AS CONSTRUCTED PLANS

PROJECT NO. : 8 11 50 701
F.A. NO. : FBDNHS-306(001)
T.I.P. NO. : F-2800
COUNTY : BEAUFORT
DESCRIPTION : Pamlico River Ferry Basin Ramps ON
NC-306 Between Aurora and Both.
DIVISION NO. : TWO
CONTRACTOR : HMG, INC.
812 N. ELM ST.
GREENSBORO, NC 27401
DIVISION ENGINEER : MR. G.R. SHIRLEY, JR., P.E.
RESIDENT ENGINEER : MR. J.A. WOLF, JR., P.E.

LOCATION : N.C. 306 AT PAMLICO RIVER FERRY
 TYPE OF WORK : GRADING, PAVING, BULKHEAD REPLACEMENT,
 RECONSTRUCTION OF FERRY RAMPS, AND STRUCTURES

STATE OF NORTH CAROLINA DEPARTMENT OF TRANSPORTATION HALESON					
STANDARD 3'-0" x 1'-6" PRESTRESSED CONCRETE CORED SLAB UNIT NORTH RAMP					
REVISIONS					
NO.	BY	DATE	NO.	BY	DATE
1	FAM	7-14-93	2		
					SHEET NO. 2112

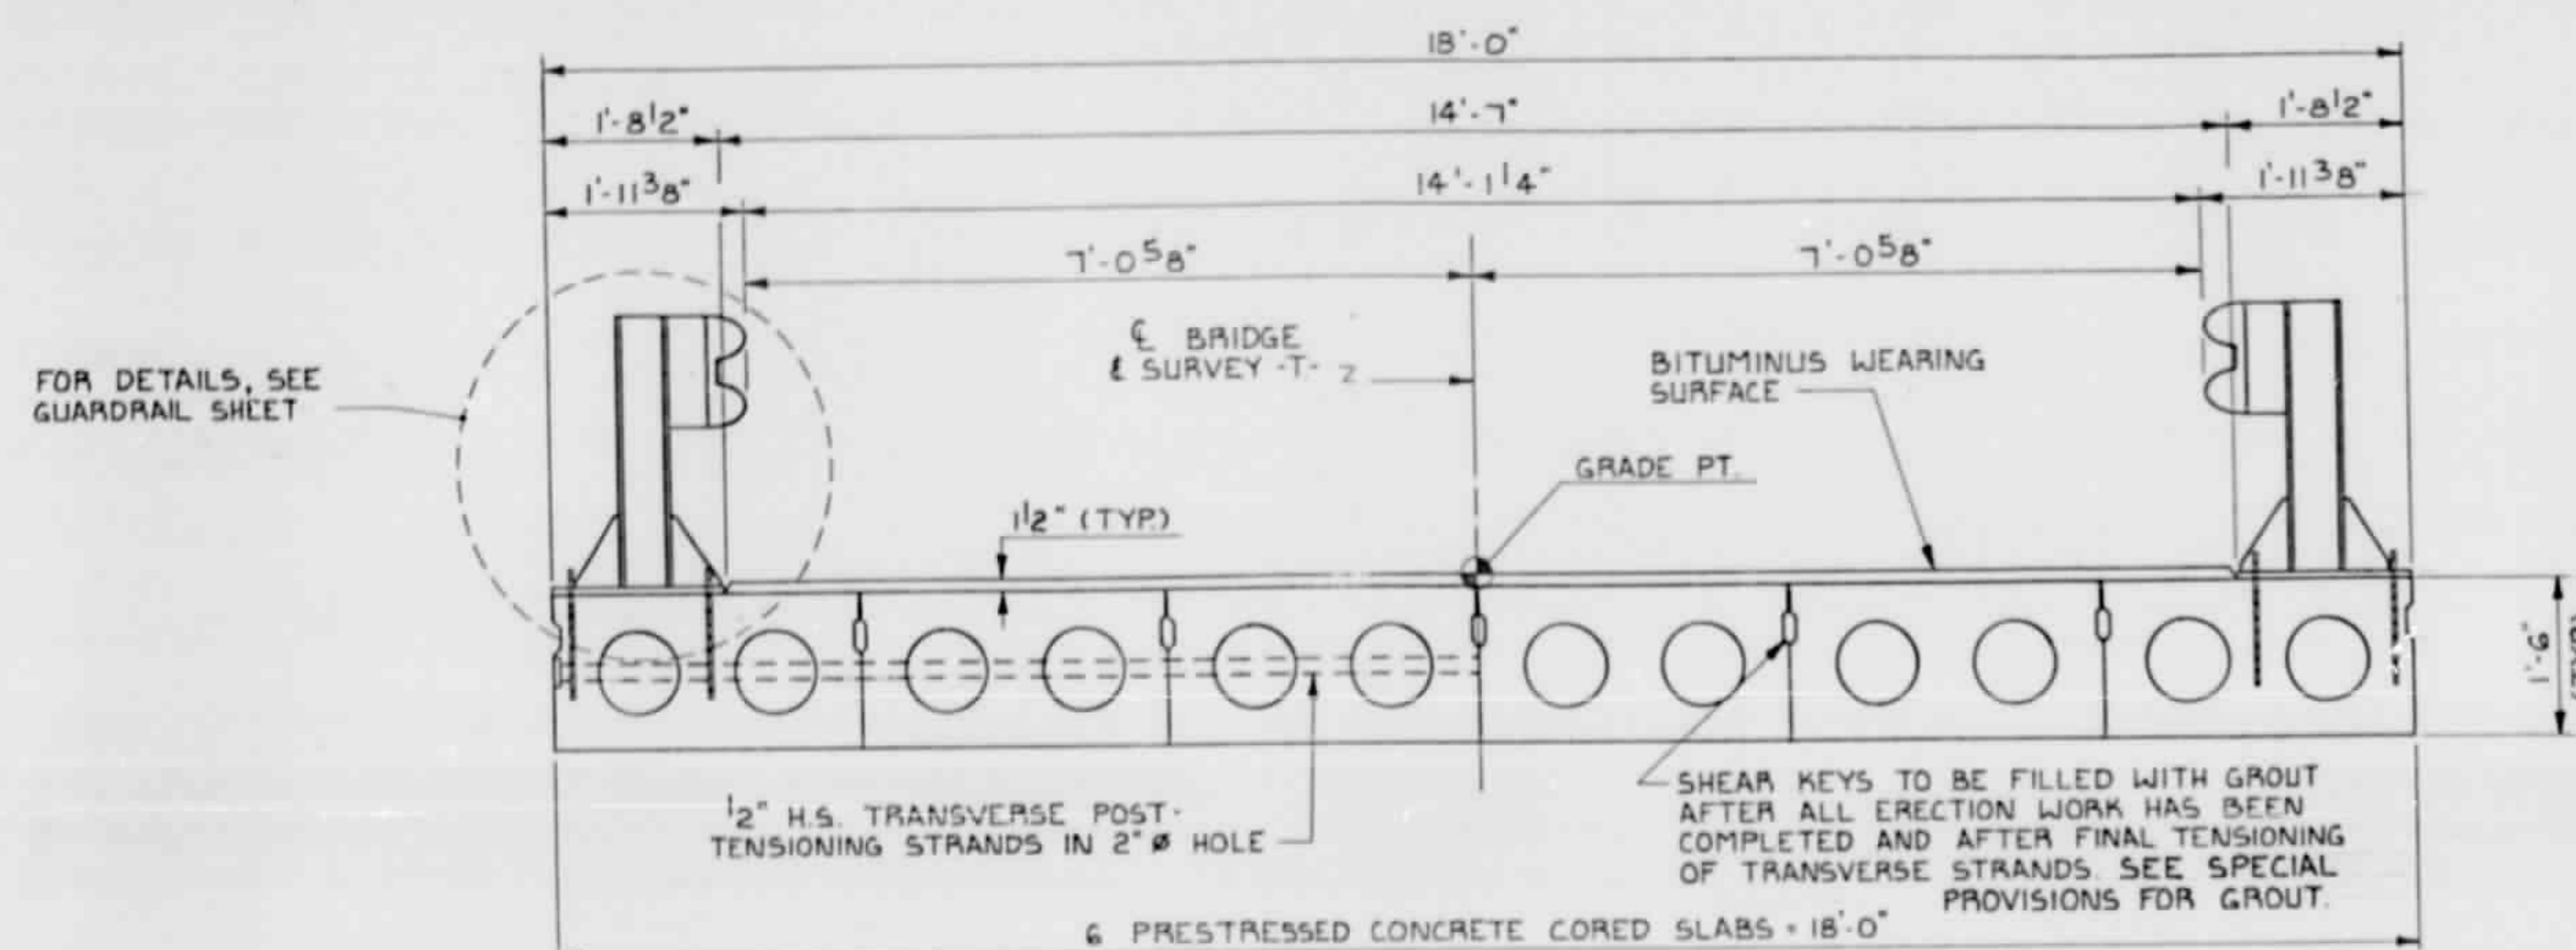
Rev No. 1: Changed Number of Strand For One Cored Slab in Bill of Material. By F.A.M. date 7-14-93 / B.Y. 107443

STANDARD
3'-0" X 1'-6"
PRESTRESSED CONCRETE
CORED SLAB UNIT
SOUTH RAMP

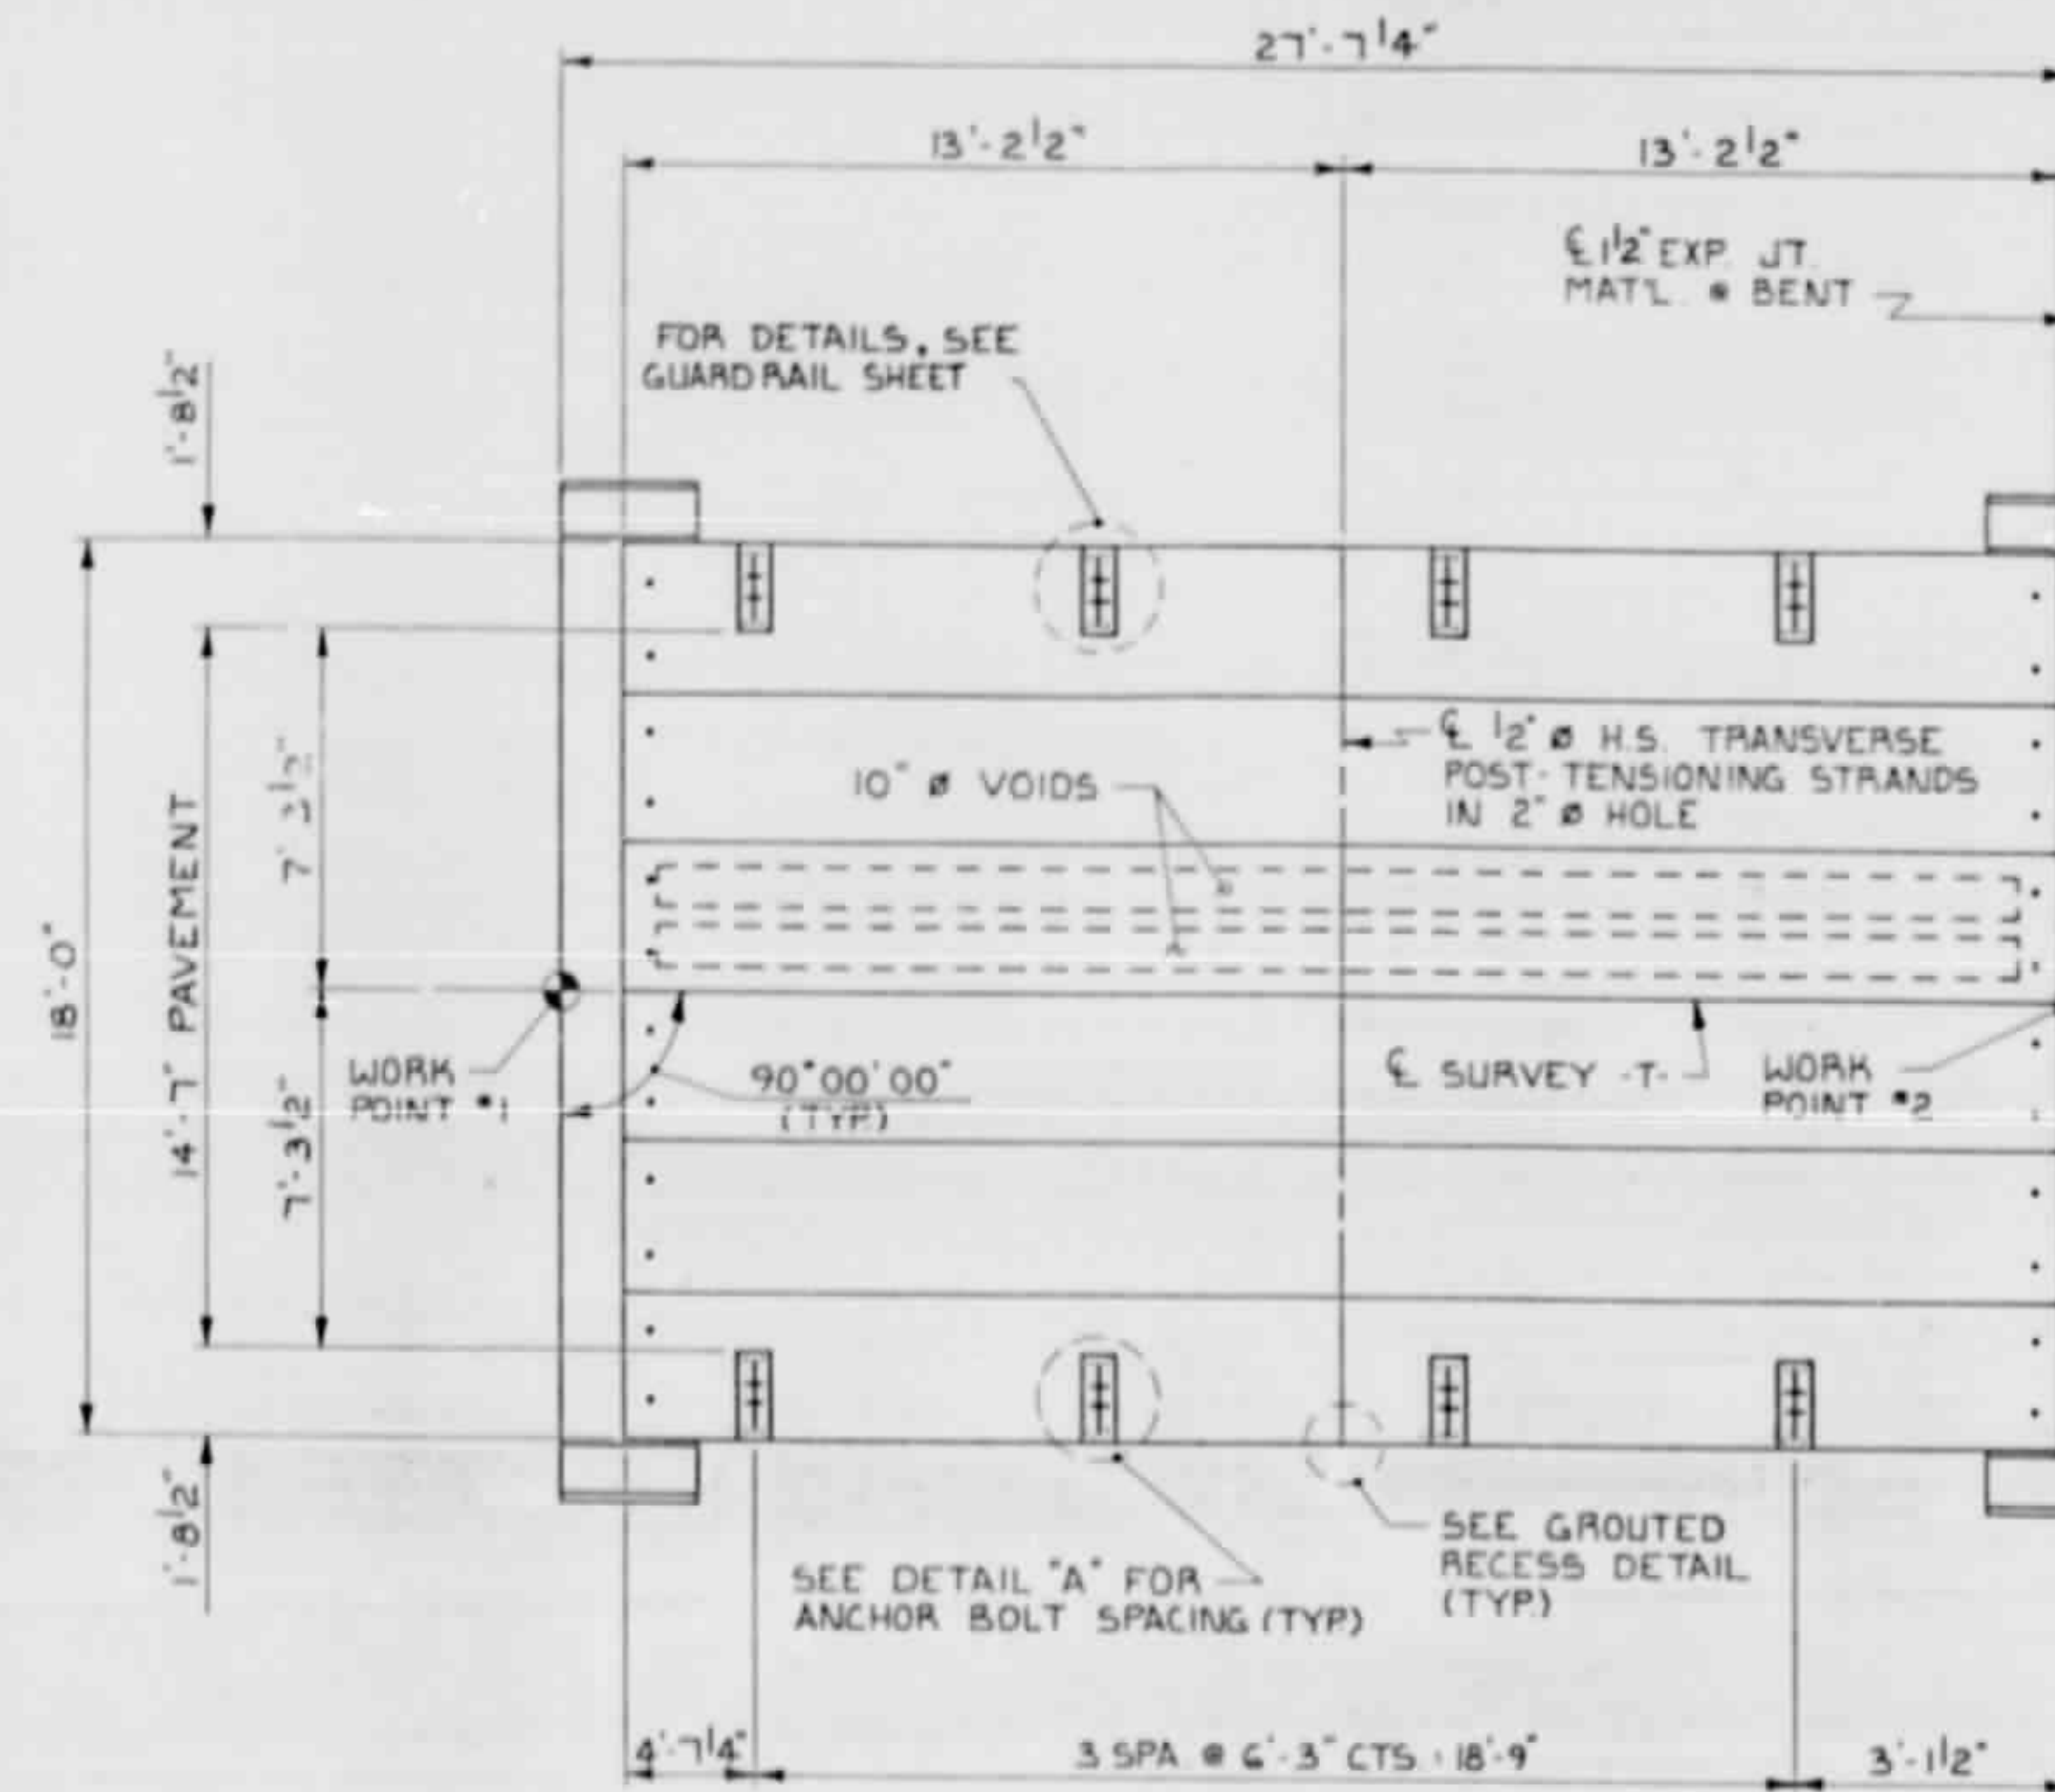
Rev. No. 1: Changed Strand Pattern. By: FAM Date: 7-14-93/8/18/11/93
